November 30, 1977

Dockets Nos.: 50-247
and 50-286 ✓

The Commission has issued the enclosed Amendment No. 36 to Facility Operating License No. DPR-26 and Amendment No. 10 to Facility Operating License No. DPR-64 for the Indian Point Nuclear Generating Units Nos. 2 and 3, respectively. These amendments consist of changes to the Technical Specifications in response to your applications transmitted by letters dated July 20, 1977.

Amendment No. 36
License No. DPR-26

Figure 6.2-1 Facility Management and Technical Support Organization

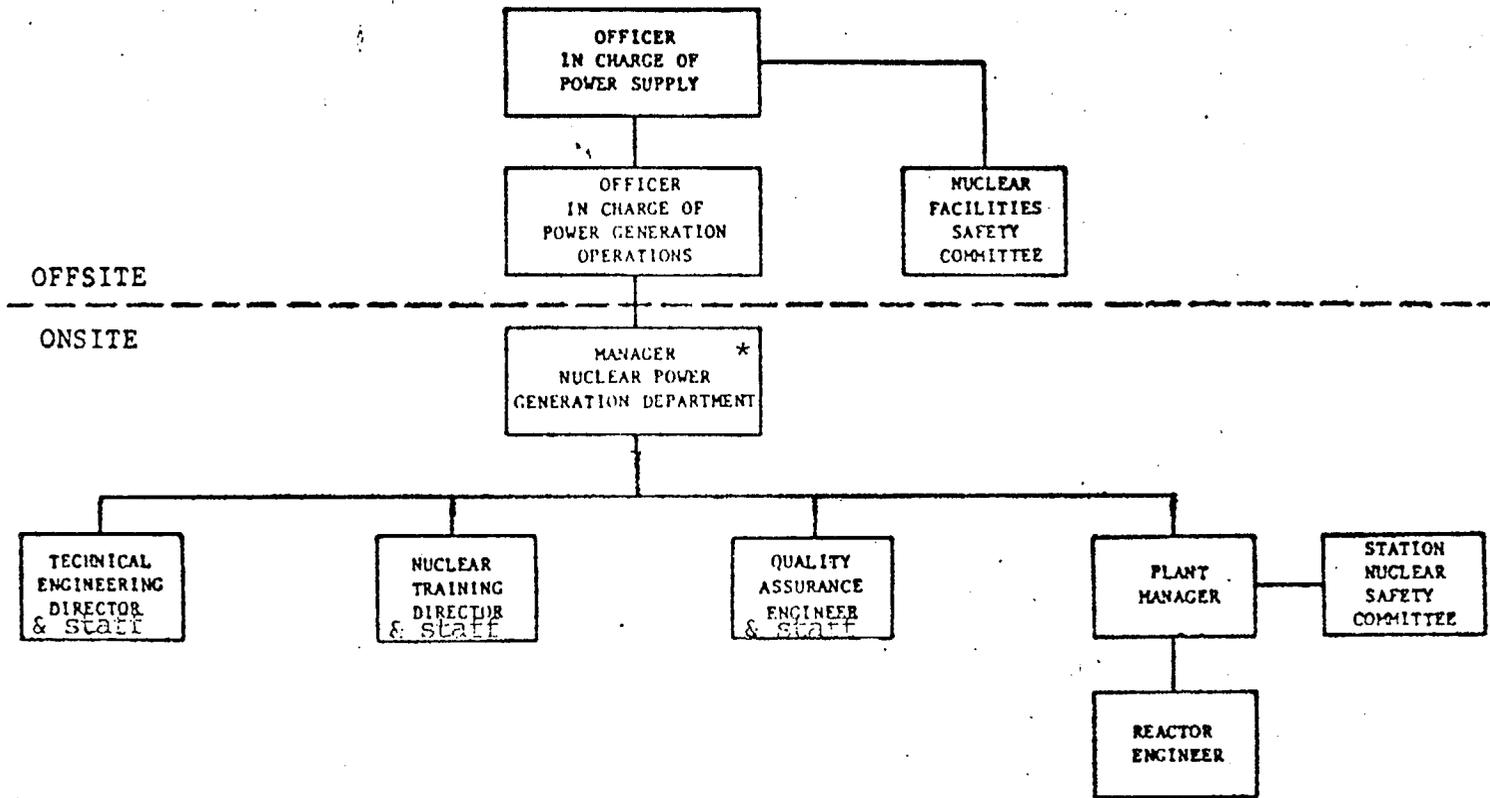
6.2.1 The organization for facility management and technical support shall be as shown on Figure 6.2-1.

* Responsible for performance and monitoring of the Fire Protection Program

Figure 6.2-1 Facility Management and Technical Support Organization

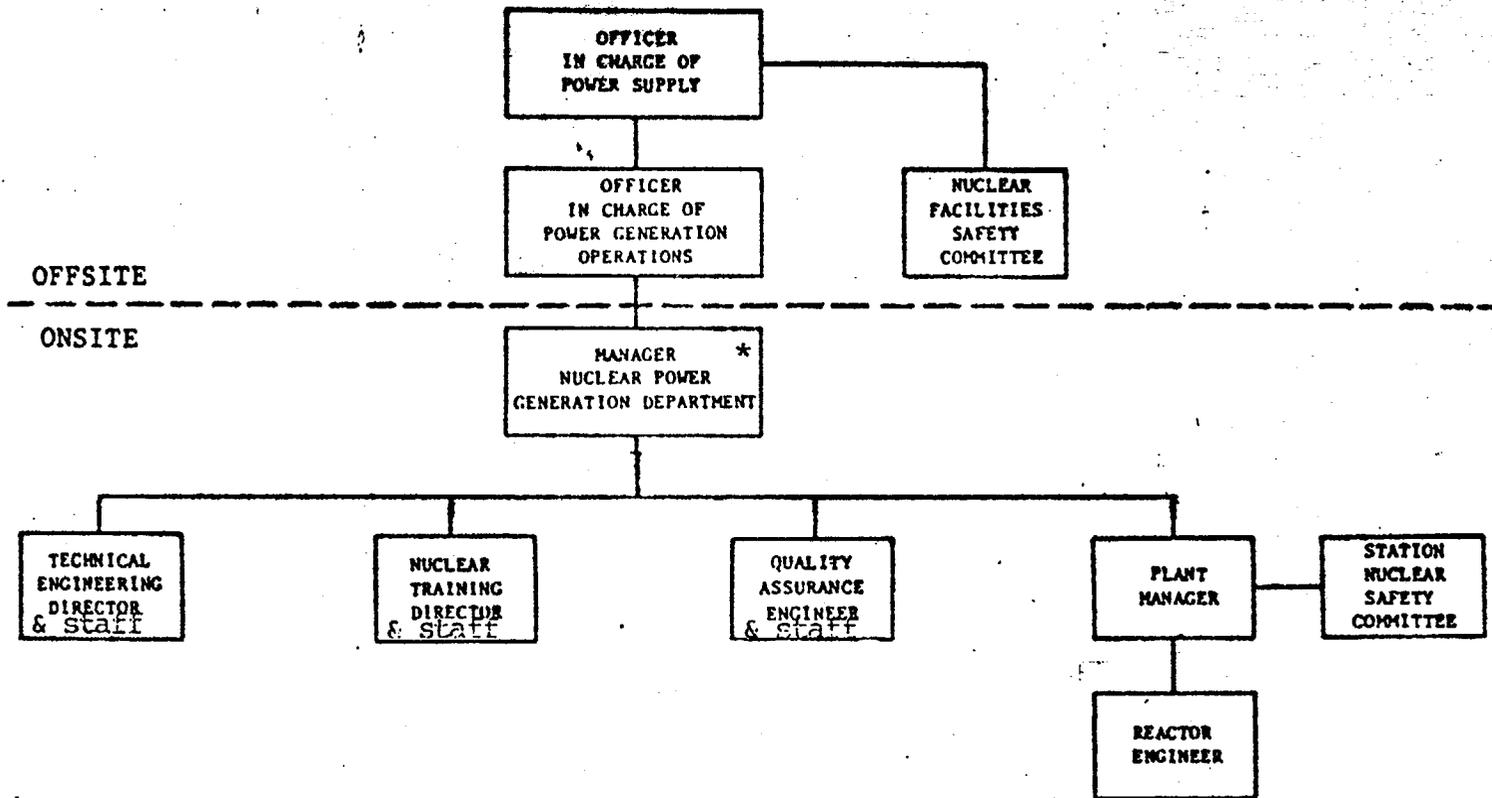
6.2.1 The organization for facility management and technical support shall be as shown on Figure 6.2-1.
